Re: 101 Brookmans Avenue, external lighting scheme

I write to provide a supporting ecological statement for an updated lighting scheme at 101 Brookmans Avenue, Brookmans Park.

Client: Seqoya		Site: 101 Brookmans Avenue, Brookmans Park		
Scale: 1:200 @ A1	Date: 02/08/2019	Drawn: GH/MC	Approved: RM	
Drawing Title: ECOLOGICAL ENHANCEMENTS		Drawing No: 1903-GUA-DR-L-002	Revision: P01

Figure 1. Proposed bollard light

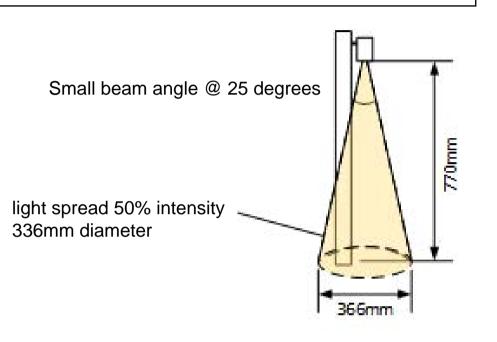
The updated lighting scheme is required to address Local Planning Authority comments, specifically requesting the following:

- That the number of lights originally planned was reduced, due to the site's immediate context on the edge of Brookmans Park residential area and backing onto an extensive golf course with mixed habitats.
- Confirmation that the lighting scheme had been prepared in consultation with an ecologist.
- Further details on the nature of the lighting; the extent to which the lights will illuminate hedges, bushes, flowerbeds, and trees; and an indication of the impact on this vegetation (i.e. why these lights will not have negative impact on the habitats, invertebrates and their prey, e.g. bats), is required.

The number of lights has been reduced from 52 to 27 and the type of light (see Figure 1) has been selected to comply with the aforementioned guidelines, as follows:

- Warm spectrum LED (2700k)
- Downward light component only, 770mm from ground
- Low brightness @ 5W
- Small beam angle @ 25 degrees
- Light spread at 50% intensity, 336mm diameter
- Set on short timers quickly switched off when not in use
- Directed onto grassed lawn

No lights are proposed along the northern boundary where the bat boxes will be sited, and this will also ensure there is no light spill onto the adjacent habitats to the north. Bollards have been sited to impact small areas of amenity lawn only, and therefore are unlikely to impact insects.

The lighting proposed will ensure that impacts on wildlife – specifically bats and hedgehog is minimised and helps to ensure their behaviour will be maintained post development. The low level, directional nature of the bollards means bat boxes installed on external walls and boundary trees will not be illuminated and importantly that surrounding habitats will not be affected.
